| Well Name: DOS EQUIS 11-14 FEDERAL COM | Well Location: T24S / R32E / SEC 11 / NENE / 32.238377 / -103.640554 | County or Parish/State: LEA / NM |

Notice of Intent

Type of Action: APD Change

Dos Equis 11-14 Fed Com 62H – API 30-025-47083

WELL LOCATION AND ACREAGE DEDICATION PLAT

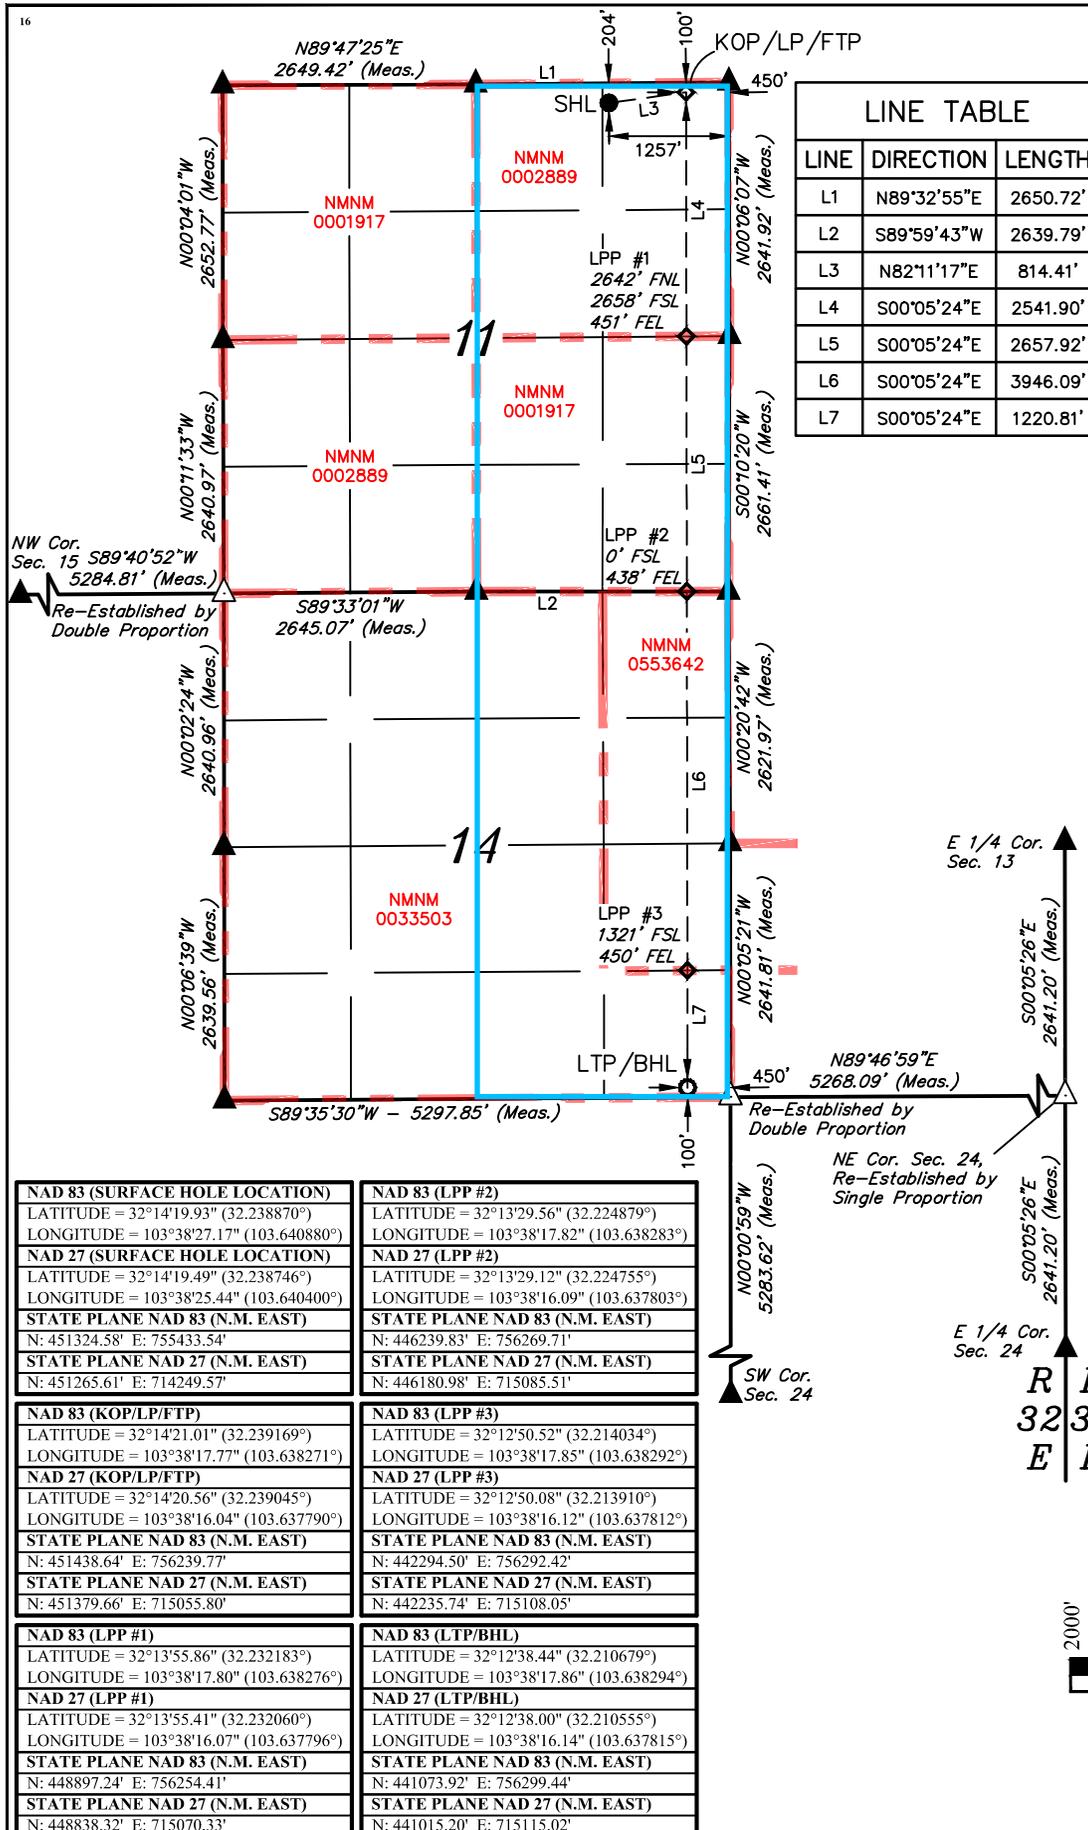
SHL/KOP Current: Unit B, Sec 11, T24S, R32E, 384 FNL & 1156 FEL

SHL New: Unit A, Sec 11, T24S, R32E, 204 FNL & 1257 FEL

LP/FTP Current: Unit B, Sec 11, T24S, R32E, 384 FNL & 843 FEL

LP/FTP/KOP New: Unit A, Sec 11, T24S, R32E, 100 FNL & 450 FEL

BHL/LTP Current: Unit P, Sec 14, T24S, R32E 100 FSL & 843 FEL

BHL/LTP New: Unit P, Sec 14, T24S, R32E 100 FSL & 450 FEL

TVD/TD Current: 12,300 TVD & 22,200 MD

TVD/TD New: 12,380 TVD & 22,561 MD
